Pentium® II Processor Specification Update

Release Date: October 1998

Order Number: 243337-019

The Pentium® II processor may contain design defects or errors known as errata which may cause the product to deviate from published specifications. Current characterized errata are documented in this Specification Update.

Figure 1. UP Dual Ended Termination (DET)

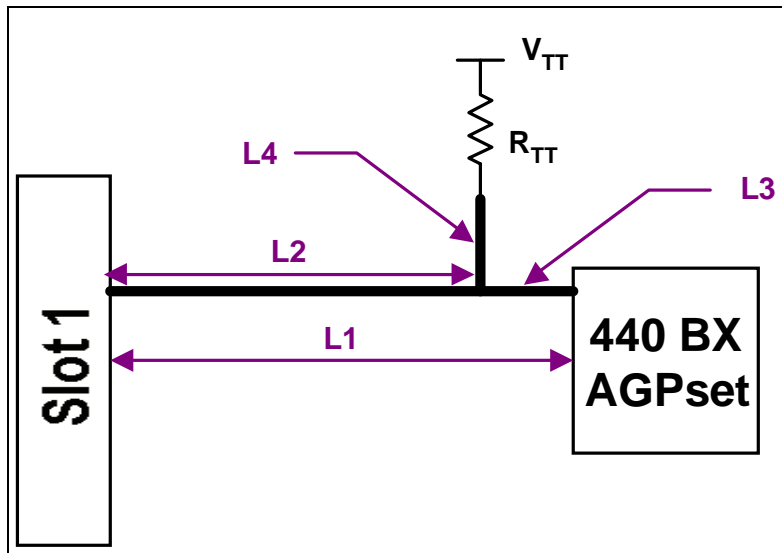
For UP-DET topologies (see Figure 1), the trace length $L1$ must be between 1.5" to 4.5" while using a 56Ω termination resistor.

Figure 2. DP Dual Ended Termination (DET)

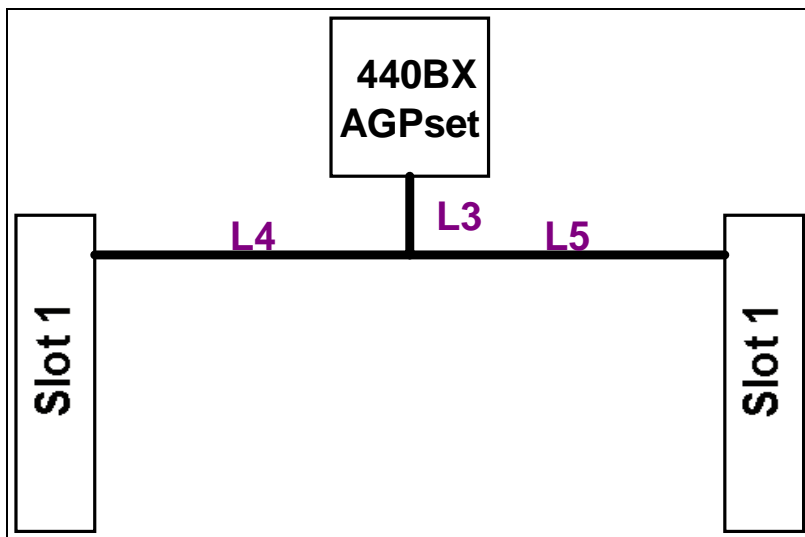
For DP topologies (see Figure 2) installed with a processor and a termination card, L4 + L3 or L5 + L3 must be less than or equal to 4.5". Additionally, for DP platforms with one processor installed, the termination card should be placed in the longer leg.

Figure 23. Processor with an Example Low Profile Heatsink Attached Using Spring Clips

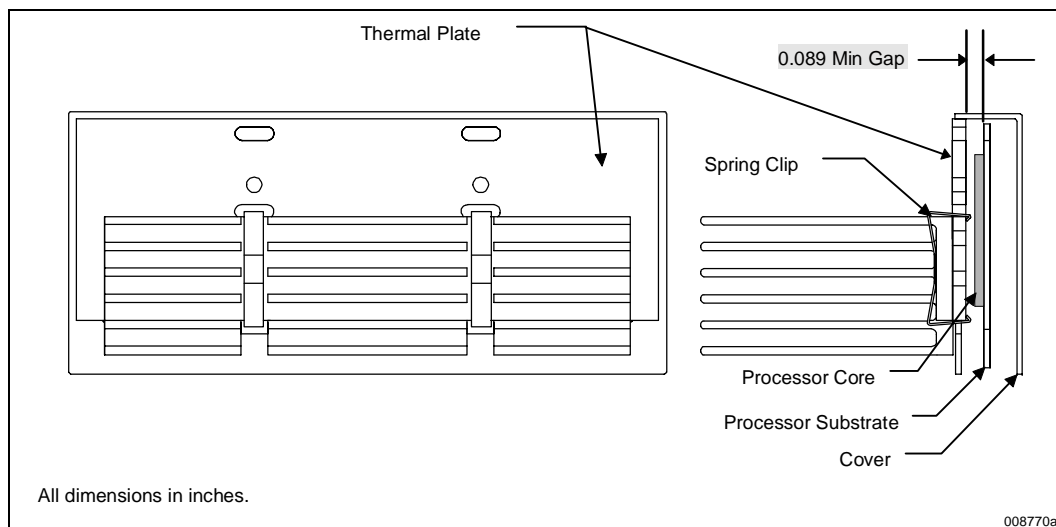
Figure 23 and Figure 24 illustrate example clip designs to support a low profile and a full height heatsink, respectively. The clips attach the heatsink by engaging with the underside of the thermal plate. The clearance of the thermal plate to the internal processor substrate is a minimum **0.089"** (illustrated in Figure 23 and Figure 24). The clips should be designed such that they will engage within this space, and also not damage the substrate upon insertion or removal. Finally, the clips should be able to retain the heatsink onto the thermal plate through a system level mechanical shock and vibration test. The clips should also apply a high enough force to spread the interface material for the spot size selected.

Figure 26. Heatsink Rivscrew* and Thermal Plate Recommendations and Guidelines

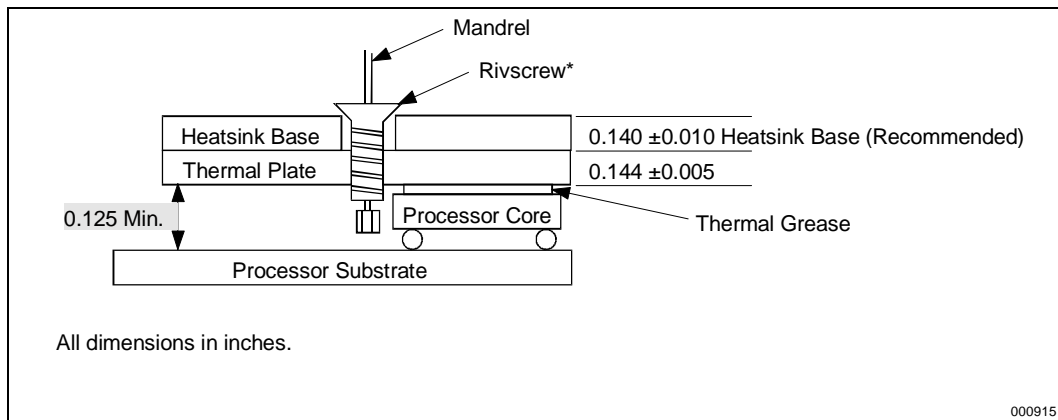
The Rivscrew attach mechanism uses a specialized rivet that is inserted through a hole in the heatsink into the thermal plate. Upon insertion, a threaded fastener is formed that can be removed if necessary. For Rivscrew attachment, the minimum gap between the thermal plate and the processor substrate is **0.125"**. For use of the Advell Rivscrew (part number 1712-3510), the heatsink base thickness must be $0.140 \pm 0.010"$. See Figure 25, Figure 26 and Figure 27 for details of heatsink requirements for use with Rivscrews.

Figure 6. BCLK to Core Logic Offset

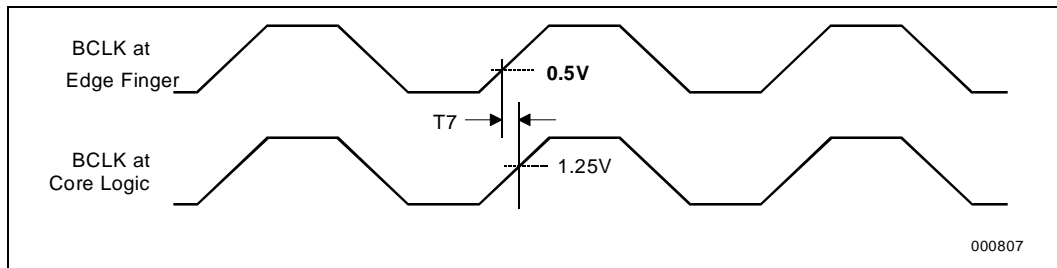
In Figure 6 of the *Pentium® II Processor at 233 MHz, 266 MHz, 300 MHz, and 333 MHz* datasheet, the following changes should be made:

Figure 7. BCLK*, PICCLK, and TCK Generic Clock Waveform

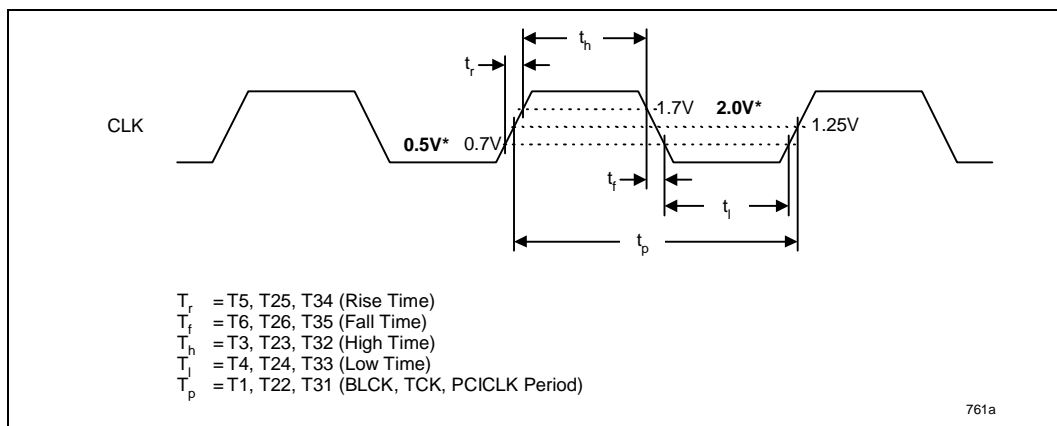
In Figure 7 of the *Pentium® II Processor at 233 MHz, 266 MHz, 300 MHz, and 333 MHz* datasheet, the following changes should be made:
